4. CASE 20.122, 20 JOHN STREET, Menzies Sweet and James Rhodes House, 1823 (COLLEGE HILL)

Proposal: The scope of work proposed consists of Major Alterations and includes:

- The applicant is requesting the removal of the of the existing dormer and the installation of a skylight, front (south) elevation.

Arrow indicates project location, looking north.

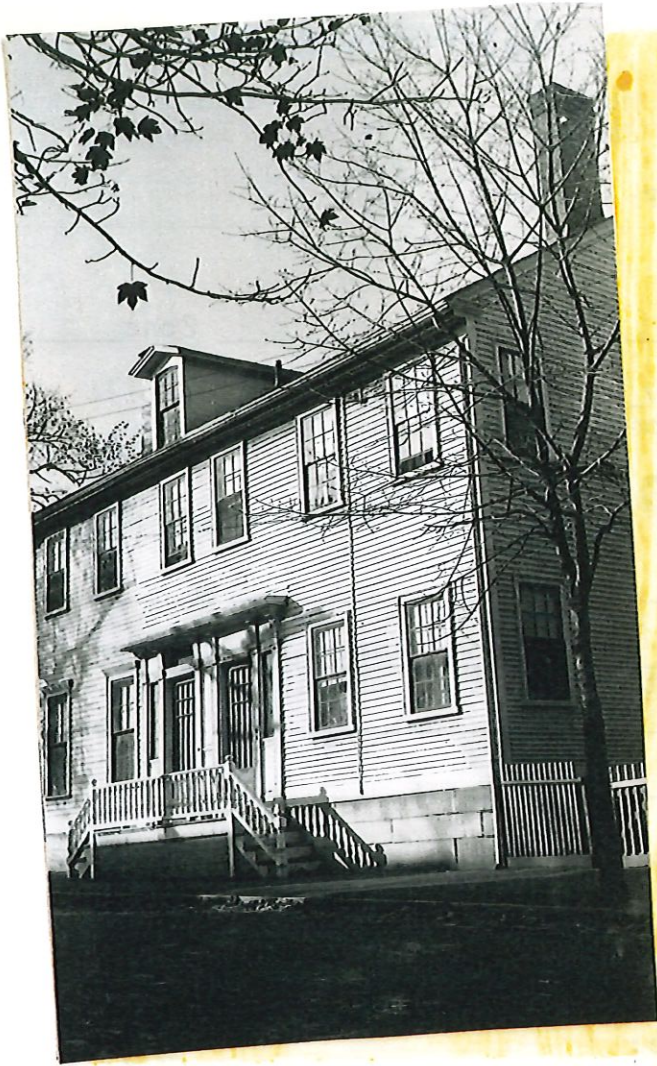
- The reason for the applicant's request is that the dormer and roof is visibly sagging. The sagging appears confined to 20 John Street, with 22 John Street's roof showing no visible discrepancy. Staff met with the owner's representative, Ross Birch, initially on October 2nd and staff recommended an engineer be consulted to determine the issues with the roof and dormer. The owner would like to remove the dormer and install a skylight in its place, presumably in an effort to save costs. Staff explained that due to the visibility of the dormer, this is not a request the Commission would typically find appropriate and that repairing the roof and dormer would be the recommended option;

- The front elevation dormer appears to date from the late 19th C. There is an extension to the property which also appears to date from the same era. The 1899 Sanborn maps shows the rear extensions on both sides of the double-house as they appear today. The dormer is asymmetrical, as 22 John does not have a dormer and there is no evidence that one once existed there. There are three dormers on the rear of the double house. One is part of 20 John and two belong to 22 John. The 1975 RIHPHC survey clearly shows the dormer (see attached). The dormer is visible from the public rights-of-ways, made more so by the view from Roome Lane south of John Street, but also noticeably visible approaching the property from the east on John Street. The dormer is clearly a significant element of the property, not original to the house, but dating most likely from the late 19th C when additions were made to the property.

- b) The application for Major Alterations may be considered incomplete; and,
- c) The proposal as submitted is architecturally and historically incongruous with the property and district as the proposed alterations will have an adverse effect on the property and district. The work as proposed is not in accord with PHDC Standards 1, 2, 6 & 7 as follows: by removing the dormer the proposal does not maintain or repair original or historically significant materials and/or features of a structure or site (Standard 1); Replacement of existing materials or features (the dormer with a skylight) does not match the old in design, color, texture and other visual qualities (Standard 2); Changes to a building or site which have taken place over time are evidence of its history and development. Those changes that have acquired significance in their own right shall be recognized and preserved (The dormer is historically significant to the property due to its age and architectural qualities as a publicly visible element of the historical evolution of the property over time, Standard 6); and, Where historic architectural or site features are determined by the Commission to contribute to the historic character of the property or the district, proposed alterations or additions affecting such features shall be reviewed more stringently (The dormer is historically significant to the property due to its age and architectural qualities as a publicly visible element of the historical evolution of the property over time, Standard 7).

Staff recommends a motion be made stating that: The application is considered incomplete. 20 John Street is a structure of historical and architectural significance that contributes to the significance of the College Hill local historic district having been recognized as a contributing structure to the College Hill National Historic Landmarks District. The Commission denies approval of the proposal as submitted, as the proposal as submitted is architecturally and historically incongruous with the property and district as the proposed alterations will have an adverse effect on the property and district. The work as proposed is not in accord with PHDC Standards 1, 2, 6 & 7 as follows: by removing the dormer the proposal does not maintain or repair original or historically significant materials and/or features of a structure or site (Standard 1); Replacement of existing materials or features (the dormer with a skylight) does not match the old in design, color, texture and other visual qualities (Standard 2); Changes to a building or site which have taken place over time are evidence of its history and development. Those changes that have acquired significance in their own right shall be recognized and preserved (The dormer is historically significant to the property due to its age and architectural qualities as a publicly visible element of the historical evolution of the property over time, Standard 6); and, Where historic architectural or site features are determined by the Commission to contribute to the historic character of the property or the district, proposed alterations or additions affecting such features shall be reviewed more stringently (The dormer is historically significant to the property due to its age and architectural qualities as a publicly visible element of the historical evolution of the property over time, Standard 7).

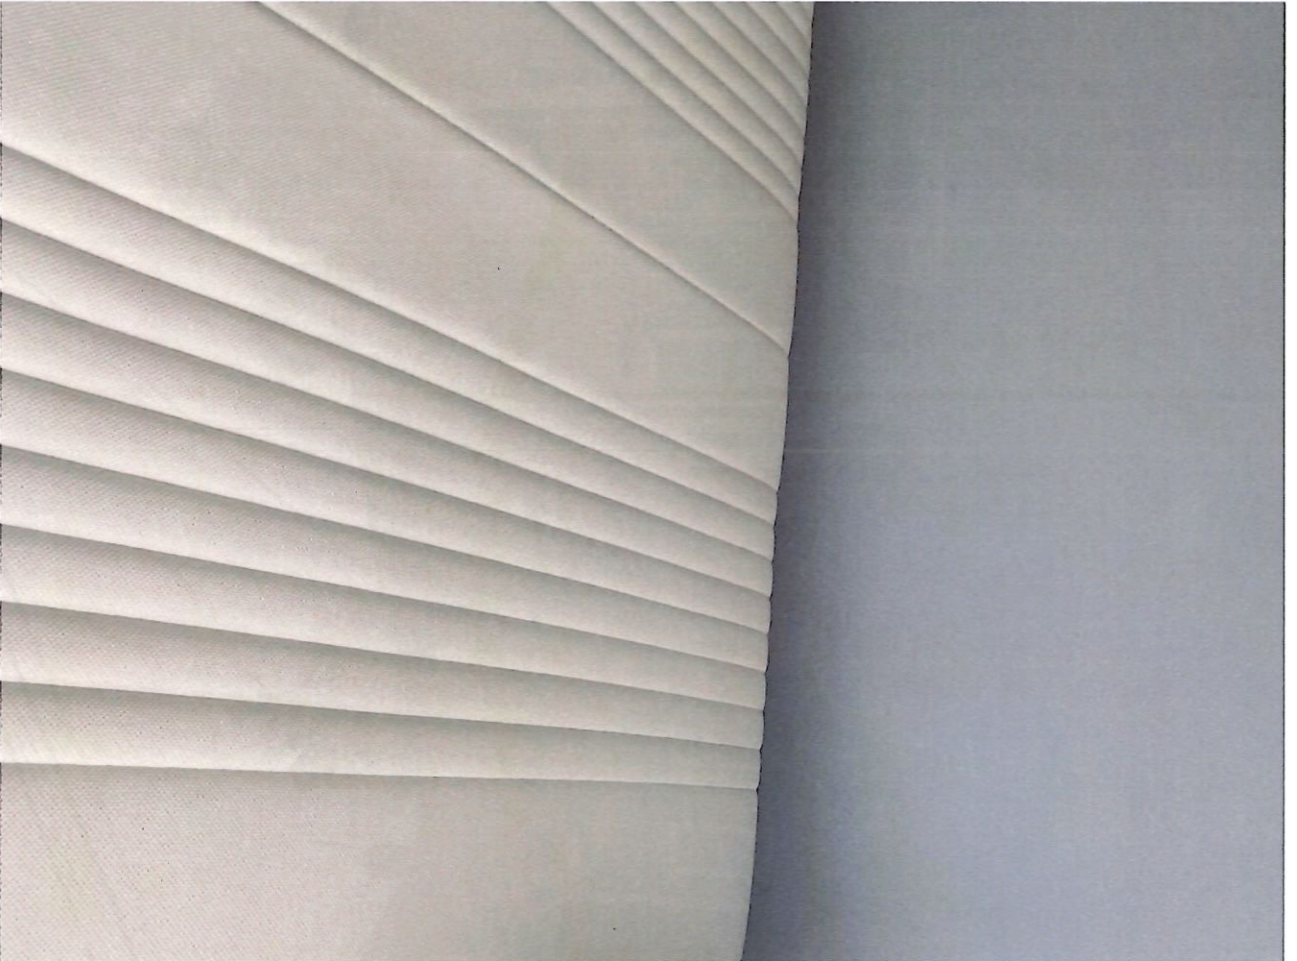
- On Tuesday, October 20th staff participated in a site visit with Ross Birch, owner's rep, and Ramzi Loqua, engineer. This visit included an external and internal visual evaluation. During the visit there was water damage to the second-floor ceiling of the front room (see photos); The third floor is a finished space, used as a bedroom. There is the front dormer, two windows in the gable end and also a rear dormer. The front and rear dormers are offset. Unfortunately, because the space is finished and currently occupied it was not possible to see any of the structure (see photos). Mr. Loqua was to return, take measurements and submit a report based on his visual examination. The report is anticipated and Mr. Loqua will be available to provide testimony at the hearing. As such, documentation for the project is limited with critical information regarding the roof and dormer's framing and structure undeterminable at this time, and may be determined incomplete by the Commission; and
